Briefing Note for Pewsey CATG / LH&FIG

Area Board Issues 6374 and 6541 – The Triangle, Upavon Junction of A345 and A342 – Road Safety Concerns

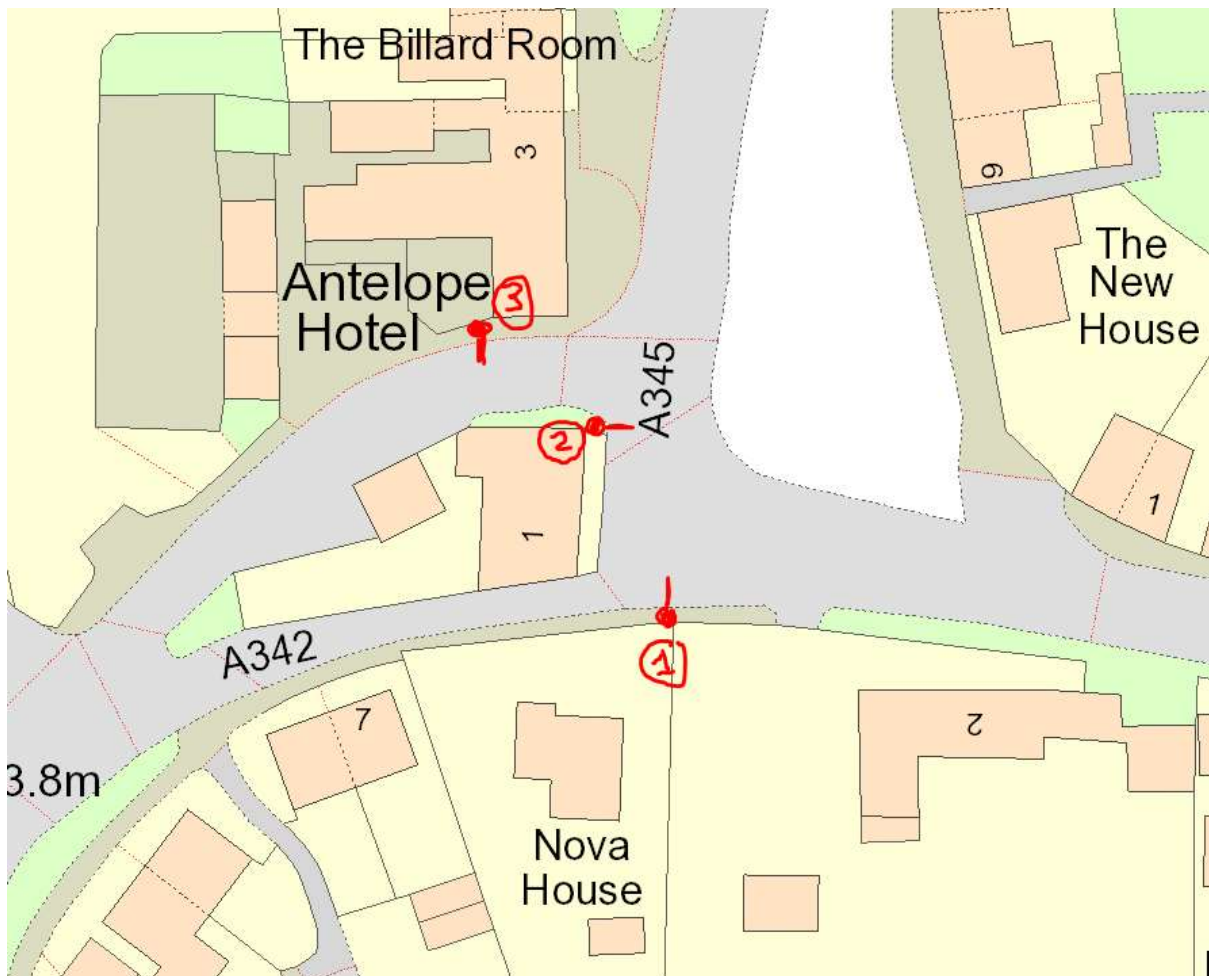
A345 Southbound approach (google image July 21)

A342 Westbound approach Andover Road (google image July 21)

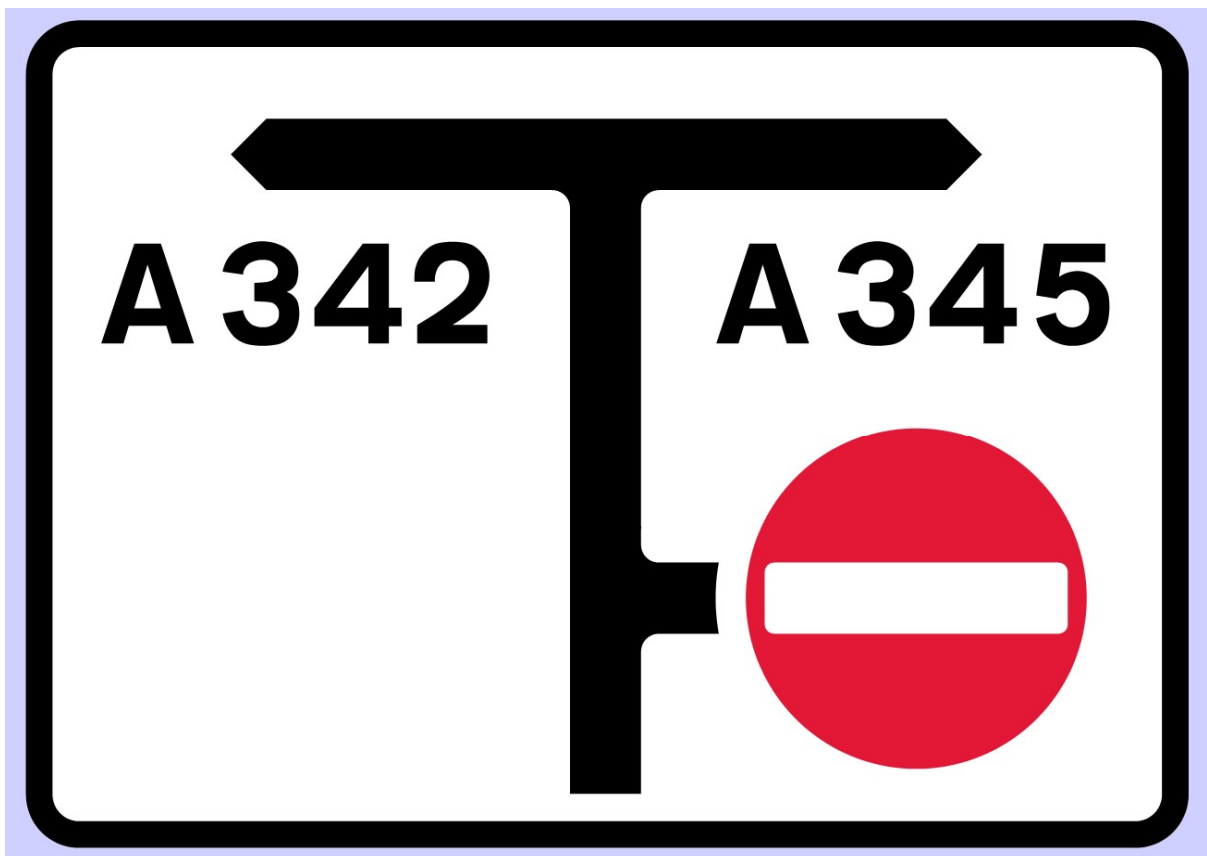
1. Provide additional lighting column avoiding tree canopy
2. Replace illuminated No Entry signpost with new lighting column and attach No Entry sign to lighting column. Sign light to be attached to column.
3. Replace illuminated Give Way signpost with new lighting column and attach Give Way sign and sign light to lighting column. Column to be placed approximately 3m west of current signpost to avoid overhanging roof.

Atkins also confirmed that there is power to the light unit above the advance give way sign on Andover Road, but a fault in this unit had been detected. This will be repaired as part of the routine maintenance programme.
